Addendum No. 1
Questa Citizens Ditch Association
Flume Replacement Project

Item 1 – Clarification of types of rock described in the Construction Plans - Bid Items No. 11 and 12

QUESTA CITIZENS DITCH ASOCIATION
FLUME REPLACEMENT PROJECT
QUESTA, NEW MEXICO

Designed:	Drawn By:	Checked By:	
AMS	AMS	SFS	
Project Number: 350552601	Date: APRIL 30, 2026		Sheet: C1

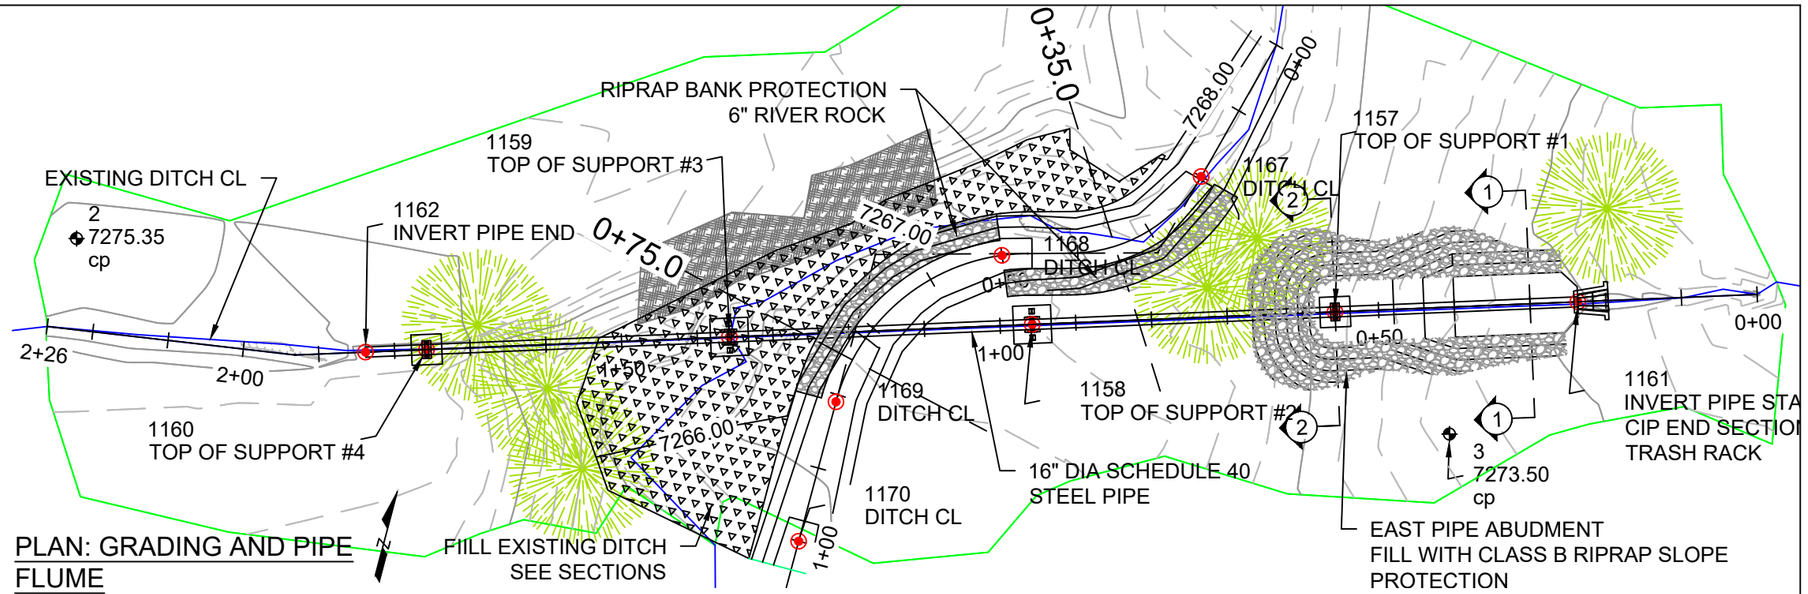
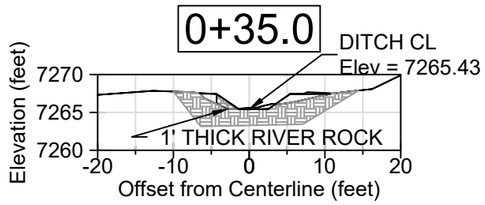
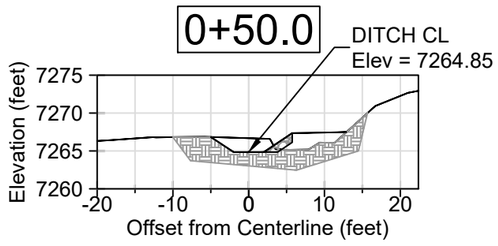
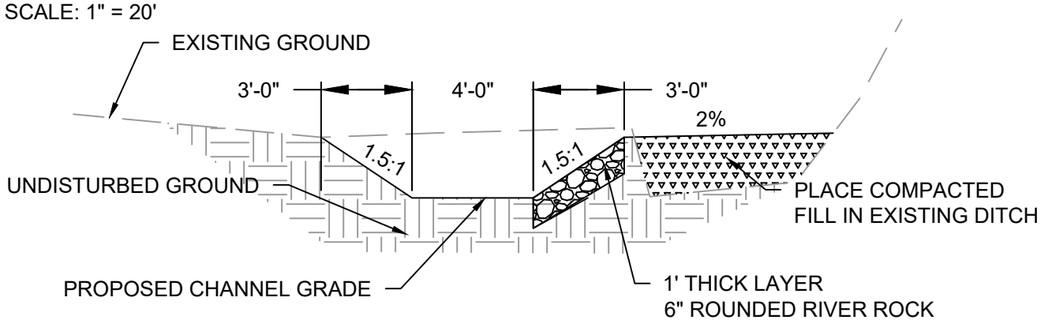
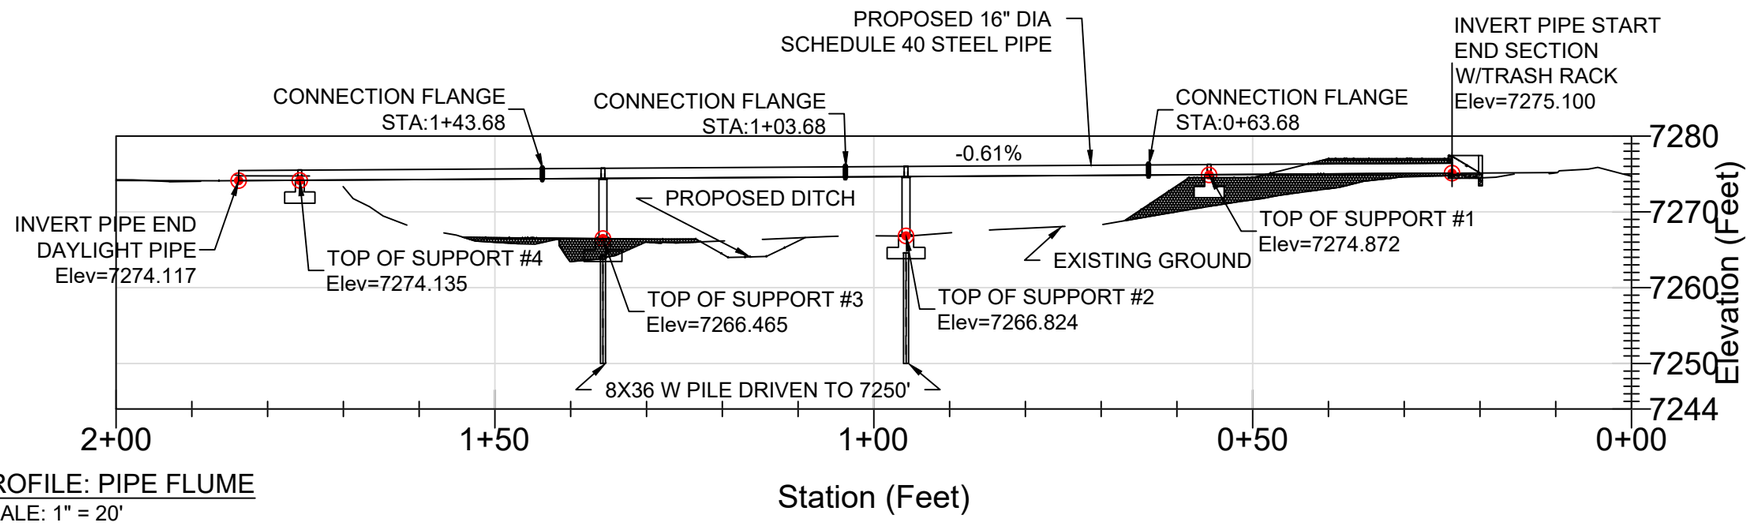
The Construction Plans call for two types of rock. Their intended uses are as follows:

1. Class B Riprap (Bid Item No. 11): Place on the graded slopes of the east abutment that supports the steel pipe.
2. 6-inch River Rock (Bid Item No. 12): Place as bank protection along the outside bank of the ditch grading.

The two rock types are not interchangeable. Do not substitute one for the other without written approval from the Engineer.

Construction Plan Sheet C1 has been revised to reflect this clarification. The revised Sheet C1 is attached to this Addendum and supersedes the previously issued sheet.
